EEE Modifications

P802.3bj comments 115, 116, 117

*P802.3bm – describe fast-wake signaling
compatible with OTN mapper*

Figure 78–3—Overview of EEE LPI operation

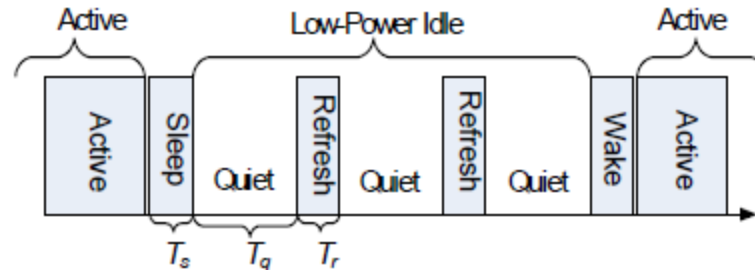
- With “Fast Wake”, there is no Quiet period since the transmitter is left on. Refresh is implicit since the transmitter is not disabled. There is no “Sleep” signal needed as the transmitter will never go quiet. T_s , T_q , T_r are all irrelevant

Figure 78-7-Overview of Fast Wake Operation

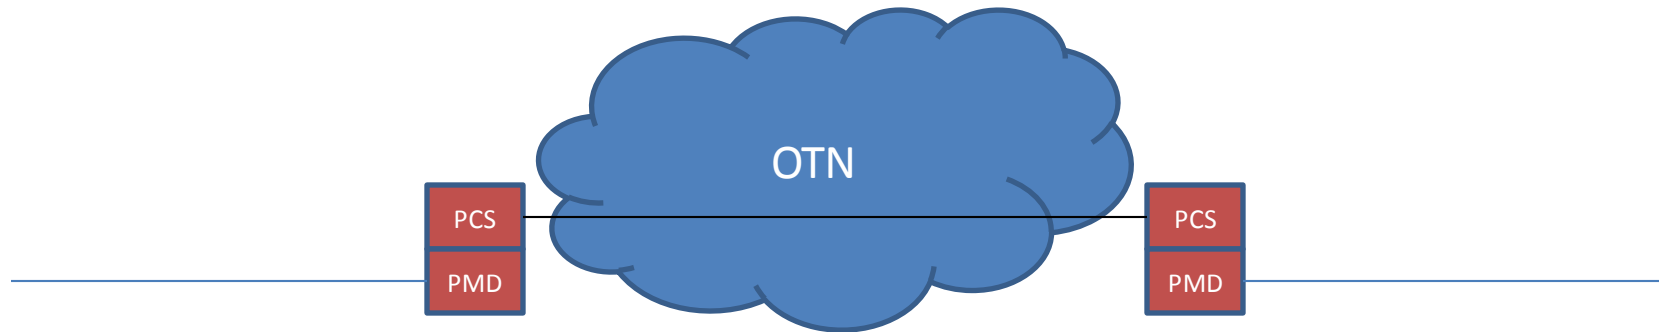
- Note that Rapid Alignment Markers are needed for the “Refresh” and “Wake” steps of the “Deep Sleep” process of Figure 78-3. They are not needed at all for the process of Figure 78-7 which can tell that the link is up without “refresh”, and can switch from active to fast-wake signaling without the warning needed if the Tx were to be disabled.
